MEMORANDUM

SUBJECT: City of Chino, Chino Gateway Terminal Project (PL24-0097, PL24-0098, PL24-0120) Response to Comment on Addendum to the City of Chino General Plan EIR (SCH 2008091064) for the Chino Gateway Terminal Project, September 16, 2025 City Council Agenda Item 17

Figure 4: Existing And Approved Warehouse Projects Near Project

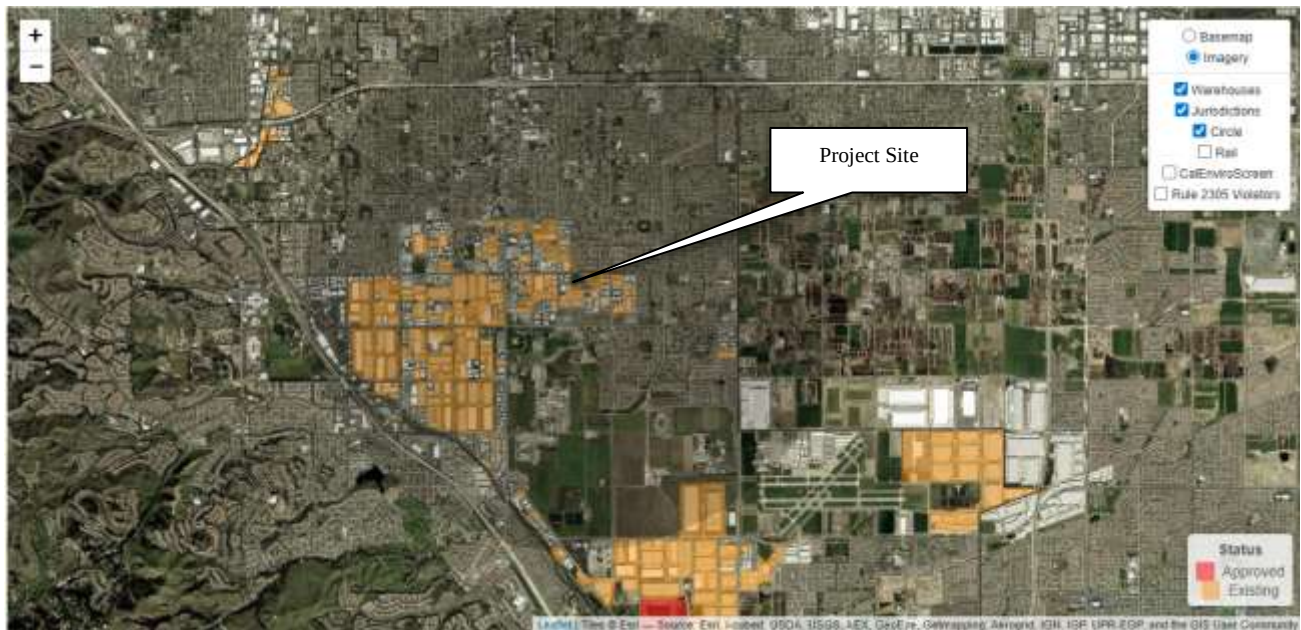
Within 5 kilometers of the project site, there are 167 existing warehouse projects totaling 25,011,300 square feet, with an additional nine (9) vacant warehouses covering 1,288,700 square feet.

Figure 8: Valley Fever Incidence And Soil Disturbance

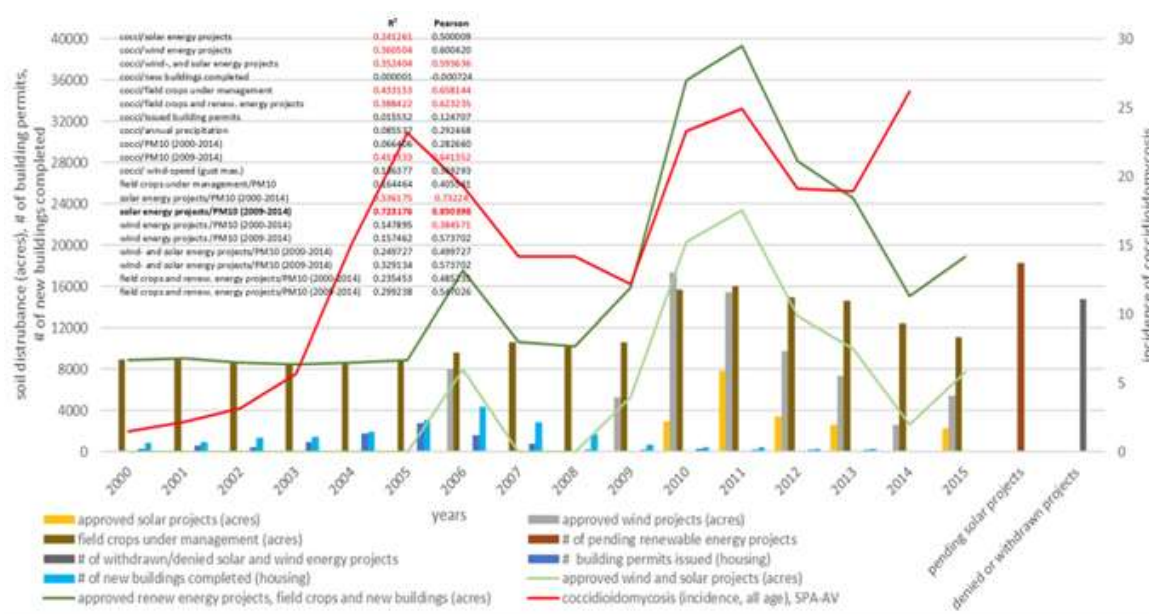
A study in Antelope Valley identified a clear link between soil disturbance - due to large-scale renewable energy construction projects, agricultural management practices and PM₁₀ fugitive dust emissions - and increased incidence of coccidioidomycosis.⁸

It is evident from the figure above that, as the number of acres of soil in the Antelope Valley were disturbed, the incidence rate of Valley Fever also increased. The mass disturbance of soils

Figure 3-6 Community Reaction to New Noise, Relative to Existing Noise in a Residential Urban Environment

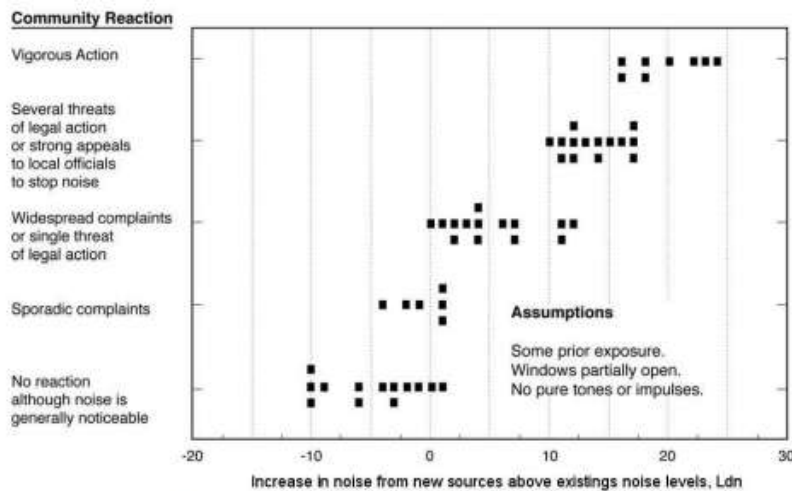
construction noise levels from demolition and grading of 81 dBA are not only above the General Plan limit, but 8 to 13 dB above the measured ambient.

As shown in Figure 3-6 of the Federal Transit Authority Noise and Vibration Impact Assessment Manual Noise (FTA Manual)², which is based on actual case studies, community reaction to newly introduced noise gets stronger as noise above existing levels increases. Reactions to increases between 5 to 10 dB varied from “widespread complaints” to “threats of legal action.”

Figure 2 From Basner (2018), Figure 4 Probability of Sleep Disturbance

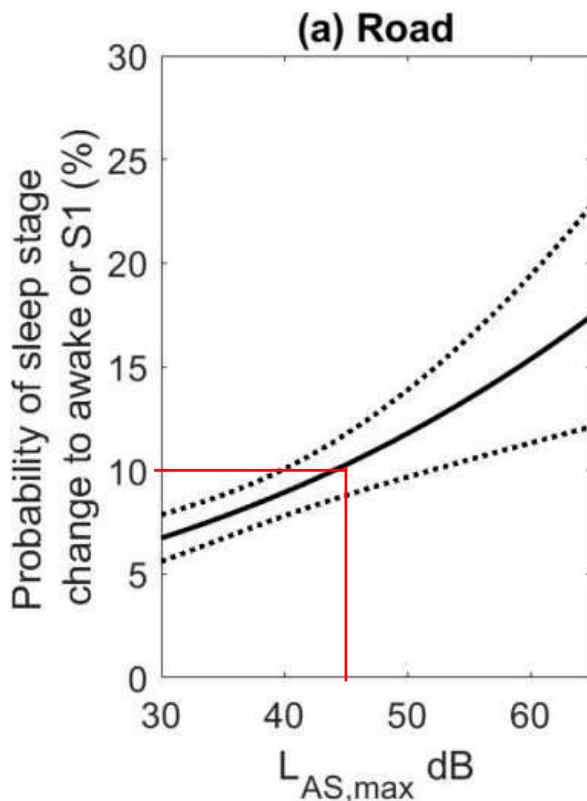
The Leq represents noise from multiple truck events over a period of time (in this case, one hour). Single event truck noise at night can cause sleep disturbance. Reliance on the hourly Leq as the significance threshold is inadequate to assess the significance of truck noise on sleep disturbance. A 2018 review article by Basner and McGuire, titled *WHO Environmental Noise Guidelines for the European Region: A Systematic Review on Environmental Noise and Effects on Sleep* and published in the International Journal of Environmental Research and Public Health (shown in Figure 2) uses data from two fairly large studies of sleep disturbance due to road traffic to estimate the effect of single traffic noise events on sleep.³

Lmax levels used in Figure 2 describe the highest “instantaneous” noise level during a specified time period, caused by short duration noises such as a truck passby, pneumatic brake air release, backup alarm, etc. As explained by FHWA-HEP-17-053, the maximum sound level is important in judging the interference caused by a noise event with common activities.⁴ FHWA RCNM uses a reference Lmax of 84 dBA for truck noise at 50 feet. As show below, this would result in an interior Lmax level of 46 dBA at the nearest residence. This assumes 15-dB reduction from a partially open window, which is standard practice for acoustical analyses in California. As shown in Figure 2, this level has an approximately 10% chance of disturbing sleep.
